FRFDA FLUSH FACE RADIAL FLOW ADJUSTABLE DIFFUSER

Shop Drawing Submittal Review

Project Name: Webster University-**ISB**

Copies	No.	Description
1 PDF	238800M08	(Submittal No.'s:) (R&B-CxSRC)
		(Cannon #238800-11) - (Paric #15051-0370) - (WES #607)
		➤ Air Distribution – Price Air Devices

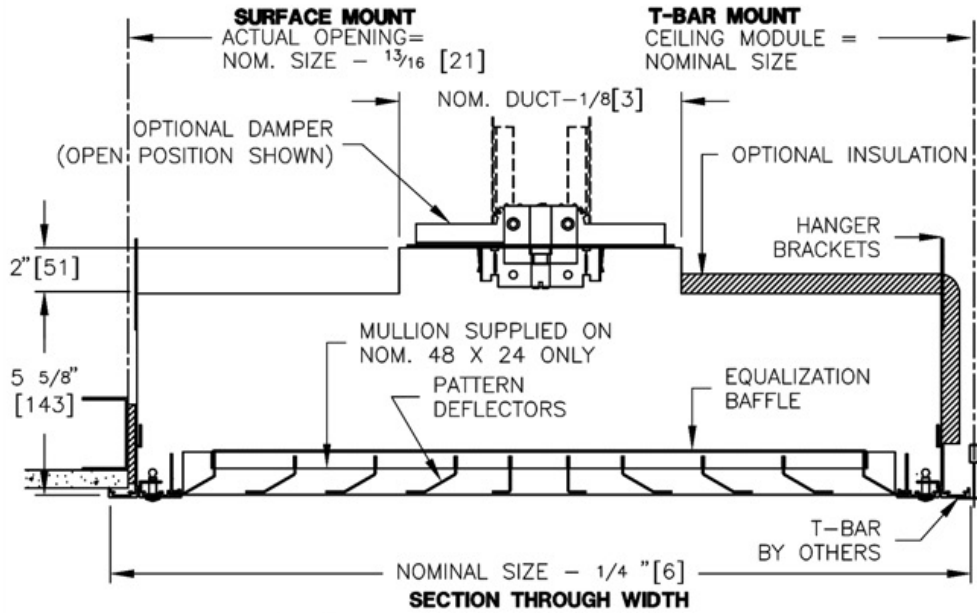
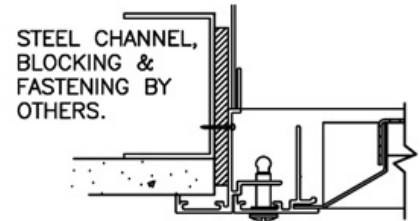
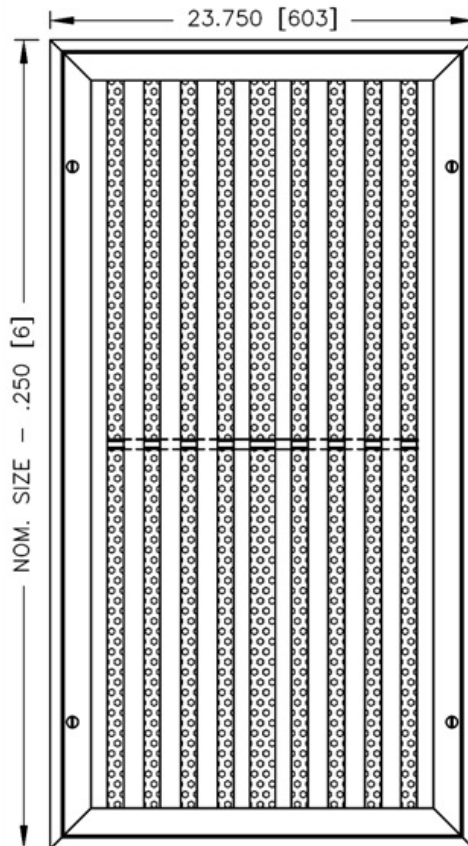
1. Confirm device quantities.
2. Verify ceiling construction with frame types.
